AMENDMENTS TO THE DRAWINGS:

REMARKS

This Amendment responds to the office action mailed November 17, 2006. Claims 1, 3-12, 14, 15, and 17-20 are currently pending. Claims 1, 3, 15 and 17 have been amended herein. Claims 2, 13 and 16 and 21-27 have been canceled without prejudice or disclaimer. New claims 28-30 have been added, support for which may be found at least in the originally filed claims and at paragraph 18 of the published application. The specification and Figs. 10 and 12 have also been amended to correct readily apparent minor errors. Reconsideration of the application is respectfully requested.

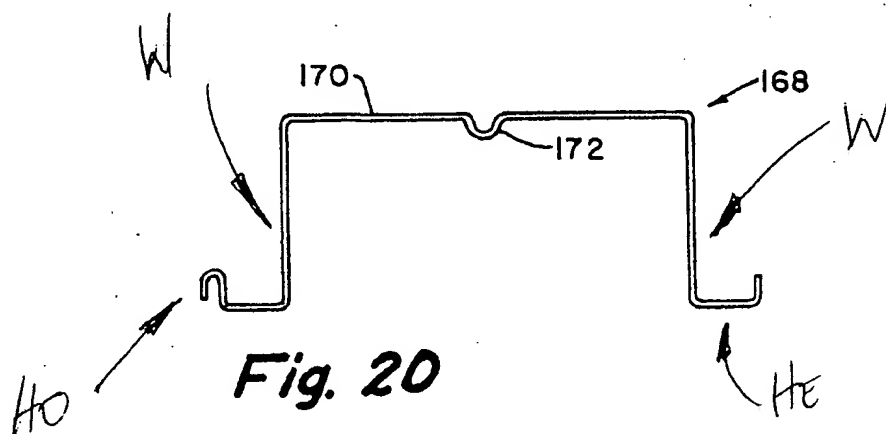
The Examiner alleges that “stiffening rib 172” illustrated in Fig. 20 of *Albrecht* (reproduced below with the Examiner’s hand drawn markings)³ corresponds to the claimed curved central portion, and that “flat region or crest 170” corresponds to the claimed side wall portions. (Office Action at p. 2.)⁴

It is abundantly apparent that *Albrecht* does not disclose side wall portions comprising straight portions that extend tangentially from a concave-shaped curved central portion since the alleged side walls 170 of *Albrecht* do not extend tangentially from the stiffening rib 172, which is alleged to correspond to the claimed concave-shaped curved central portion. Rather, Fig. 20 of *Albrecht* shows a flat region 170 with a stiffening rib 172 formed therein, such that there is a substantial reverse in curvature from the stiffening rib 172 to the flat region 170. In addition, as previously described at length in the record, the present application clearly distinguishes the claimed curved central portion from a stiffening rib or notch. Accordingly, claims 1 and 15 are

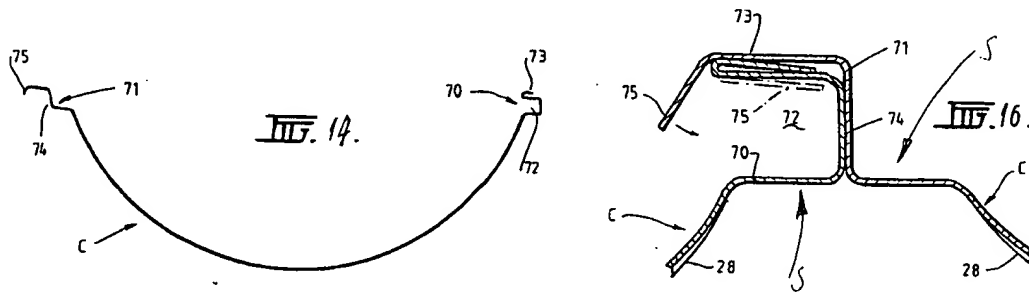
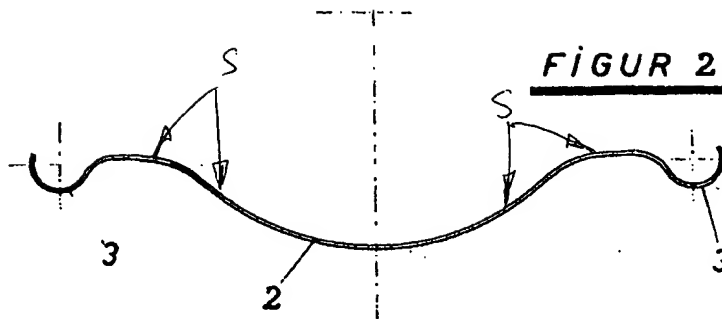
The Examiner cites Figs. 14 and 16 of *Blazley* (reproduced below with the Examiner's hand drawn markings)⁵ as allegedly disclosing the subject matter of claims 1 and 15.

The Examiner alleges that portions of the male edge flange 70 and female edge flange 71 of *Blazley* correspond to the claimed side walls (hand labeled by the Examiner as "S" in Fig. 16 of *Blazley*) and that the section labeled "C" corresponds to the claimed curved central portion. (See *Blazley* at Col. 10, lines 36-49 for *Blazley*'s use of terminology.)

However, it is readily apparent that that *Blazley* does not disclose side wall portions comprising straight portions that extend tangentially from a concave-shaped curved central portion since the portions labeled "S" do not extend tangentially from the section labeled C. Rather, there is a substantial reverse in curvature from the section C to the portions labeled S.

Moreover, a proper assessment of *Blazley* in view of the description of side wall portions and wing portions in the present application (*see, e.g.*, wing portions 908 and 910 shown in Figs. 9 and 10 of the present application) reveals that the building elements shown in Figs. 14 and 16 of *Blazley* do not possess side wall portions whatsoever. At most, the male edge flange 70 and female edge flange 71 might correspond to the claimed complementary wing portions. Viewed in this light, Figs. 14 and 16 of *Blazley* illustrate building elements having a curved portion that terminates directly at male edge flange 70 and female edge flange 71 with no side wall portions having straight portions whatsoever therebetween.

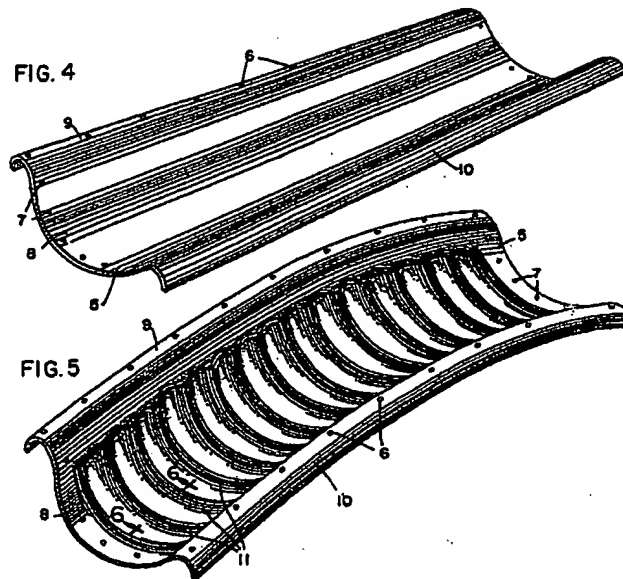
With regard to GB ‘062, the Examiner refers to features shown in Figs. 4 and 5 therein (reproduced below) as allegedly disclosing the claimed subject matter. In particular, the Examiner alleges that feature 8 corresponds to the claimed curved central portion, that features 5

and 7 correspond to the claimed pair of side wall portions, and that features 9 and 10 correspond to the claimed complementary wing portions.

However, it is readily apparent that that GB '062 does not disclose side wall portions comprising straight portions that extend tangentially from a concave-shaped curved central portion since the alleged side wall portions do not constitute straight side wall features that extend tangentially from a concave-shaped curved central portion as claimed. The regions identified by the Examiner as alleged side wall portions are curved and contain no straight portions, nor is there any other straight portion that extends tangentially from a concave-shaped curved central portion as claimed. Moreover, features 5 and 7 alleged by the Examiner to constitute side wall portions are actually referred to in GB '062 as "panel member 5" and "bolt holes 7." (*See, e.g.*, GB '062, p. 2, lines 51-60 and 124-125.) Accordingly, GB '062 does not anticipate claim 1 for at least this reason (nor would it anticipate claim 15 for at least the same reason). Claim 12 is

FIG. 10A

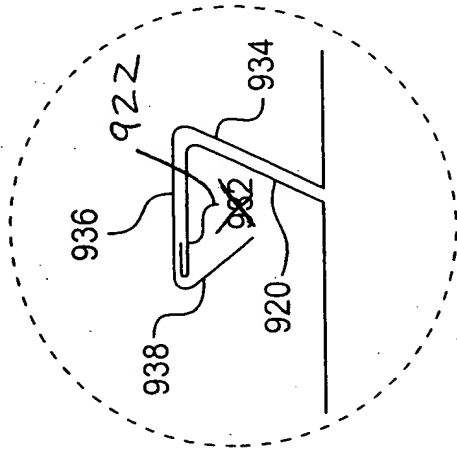
The attached sheets of drawings include changes to Figs. 10A and 12. These sheets, which include Figs. 10, 10A and 12, replace the original sheets including Figs. 10, 10A and 12. In Fig. 10A, reference numeral 932 is changed to 922 for consistency with the specification. In Fig. 12, reference numeral 1118 is changed to 1108 for consistency with the specification.
